STAFF RECOMMENDATION

Approval, with Conditions

CASE FILE NO.: Z0474-19-D

PROPOSAL: Construction of four speculative commercial buildings of 4,000 square feet each. Two of the buildings are proposed to have drive-through service. Proposed project to also include, modified site access, circulation, parking, landscaping, and other redevelopment as required by the Clackamas County Zoning and Development Ordinance.

Landscape Plan

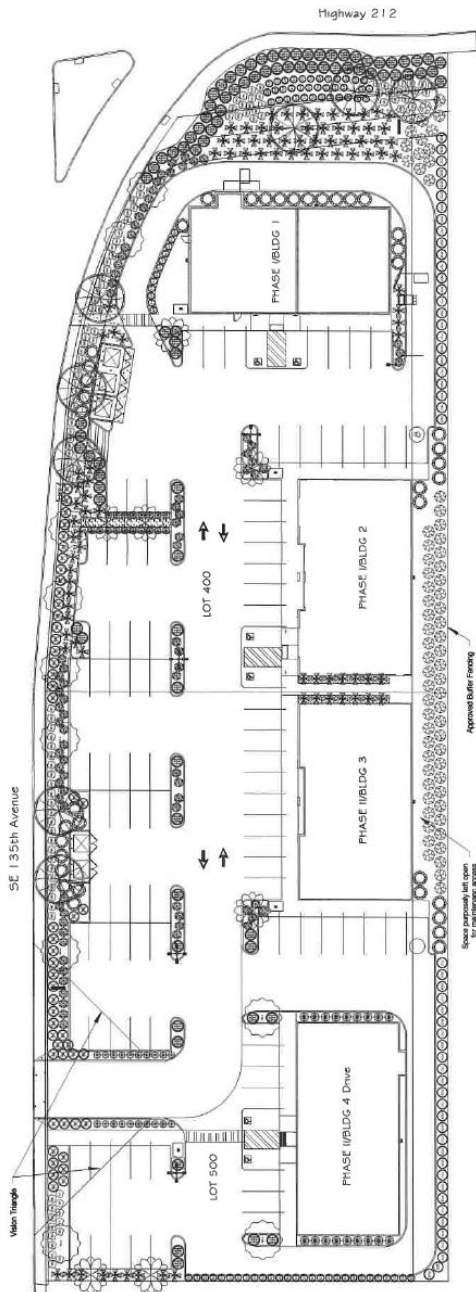
1. Prior to issuance of building permit, the applicant shall submit a site drawing demonstrating a landscape irrigation system which meets the standards of ZDO 1009.10(M).

Finding: The proposed site design will exceed the 15% requirement of the design standard. A variety of plants of various sizes, textures, and seasonal interest are indicated, none of which are invasive or noxious species. These species are predominantly native and/or drought tolerant plants, appropriate to a commercial context and the local habitat/conditions. Conditions of approval will ensure compliance with the required landscaping in terms of composition of materials, installation
